# SUPPLEMENTAL INSTRUCTION

PROJ.: Meridian Community  
Building Rebuild  
PROJ. No.: 1841  
DATE: July 24, 2019  
S.I. No. S.I. – A005

Revise Parapet Siding to Roofing Membrane

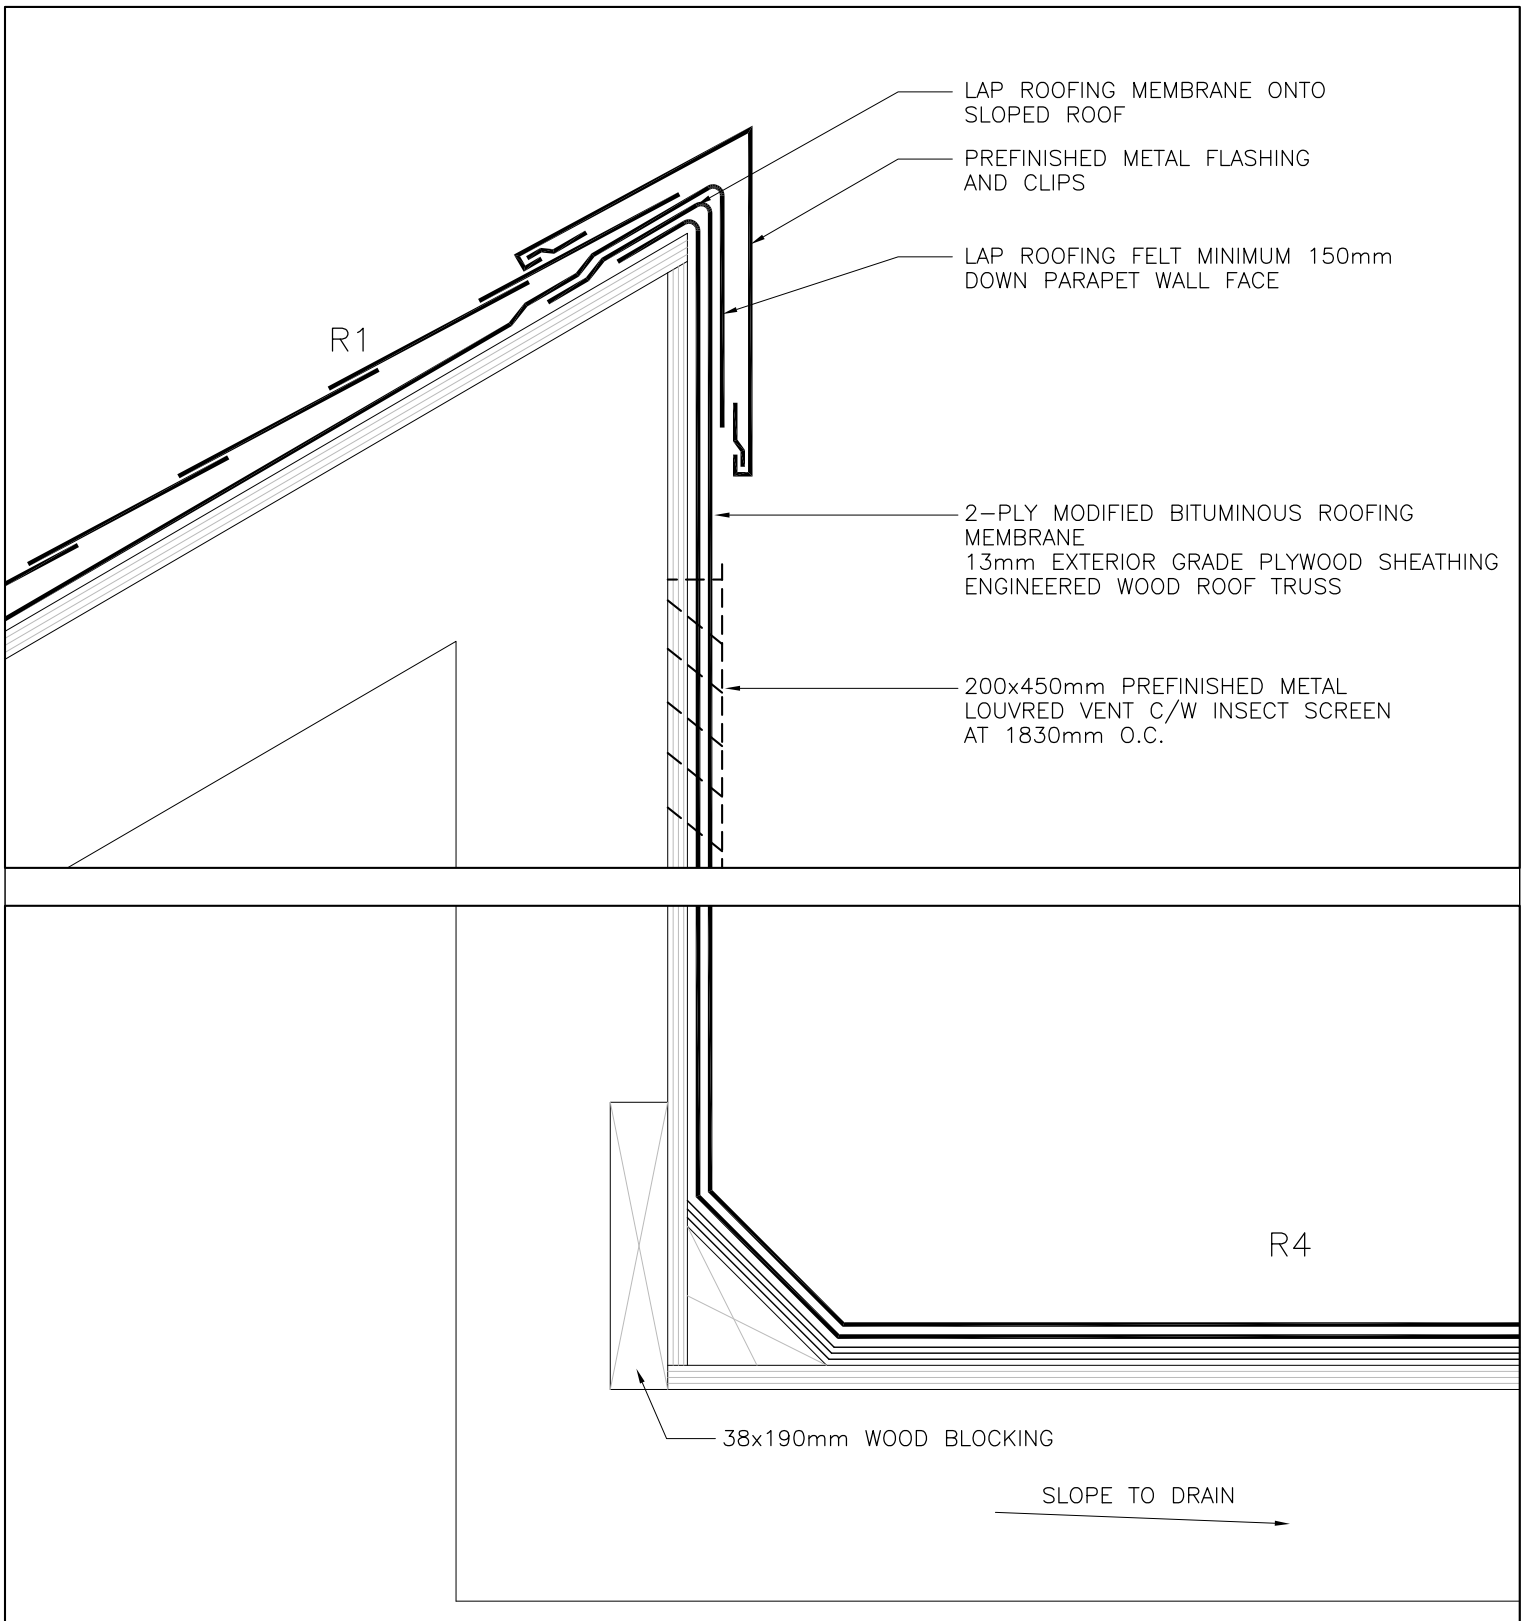
.1 Delete the Vinyl Siding noted on the inside of the parapet walls around the flat roof of the Community Building, and replace it by extending the 2-ply mod-bit roofing membranes over the top of the parapet walls. Lap the roofing felt from the sloped roof over the top of the roof membranes (minimum 150mm overlap). Cover with metal flashing – refer to attached ASK-SI-A005.1.

Shop drawing coordination – roofing contractor recommendation for warranty coverage.
